CHANGES FROM BASE PRODUCT BE-800C-C (3243C) TO BE-800C-NIR-C (4248A)

Assembly Pl Approval T.CHOI 27/10/14	Approved by B.CHILDS	Checked by R.BATES	Drawn by P.MISSEN
Angle of Projection 	Units mm	Scale N/A	Released 31/10/14
Status RELEASED		BE-800C-NIR-C	
Part No 4248A		BE-003013-00-14

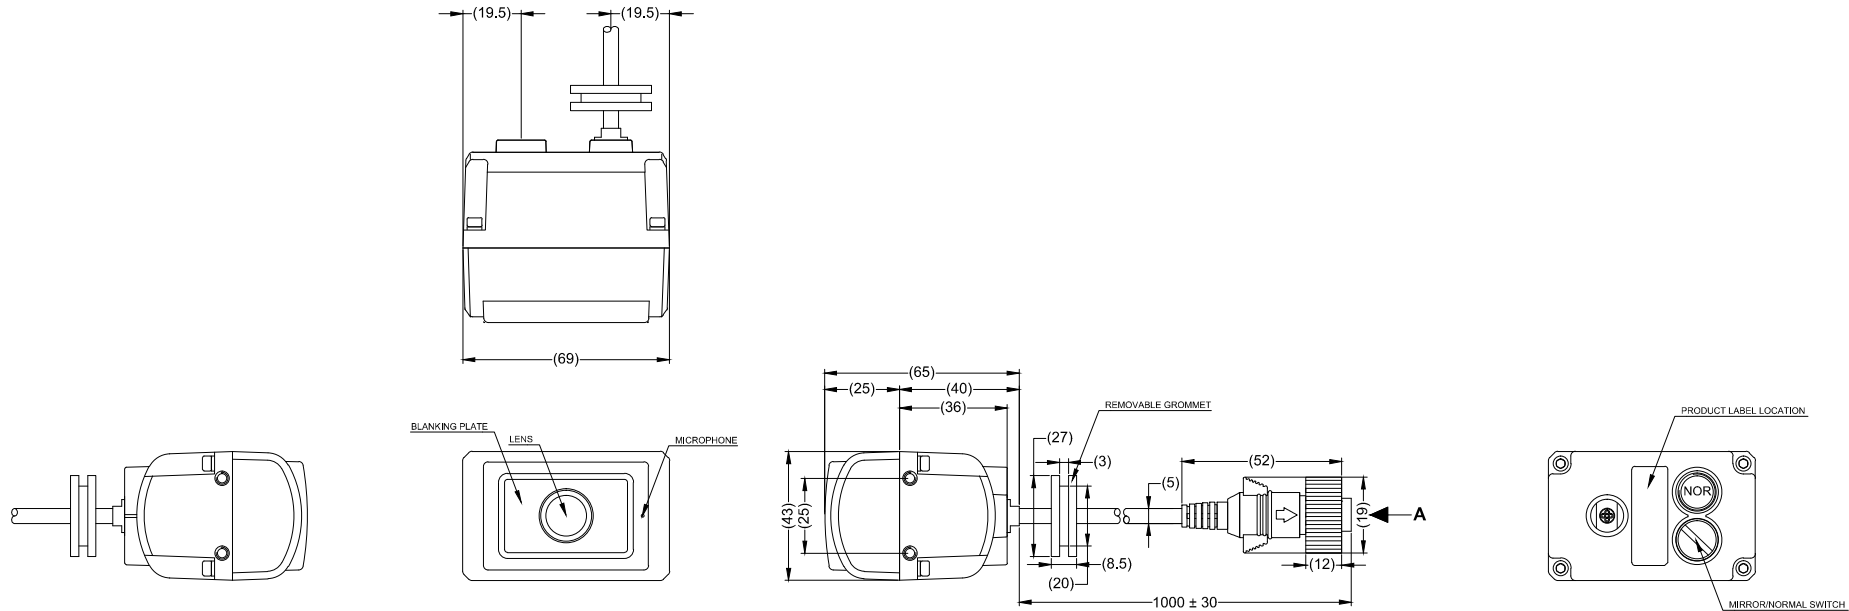
- CHANGE:
1. IR LED PCB REPLACED BY IR PCB WITH LEDS DEPOPULATED .
 2. BLANKING PLATE ADDED TO COVER IR LED OPENINGS.
 3. REPLACE BE-800C-C PD-LBL WITH BE-800C-NIR-C PD-LBL.

- OPERATION:
1. NO IR ILLUMINATION.
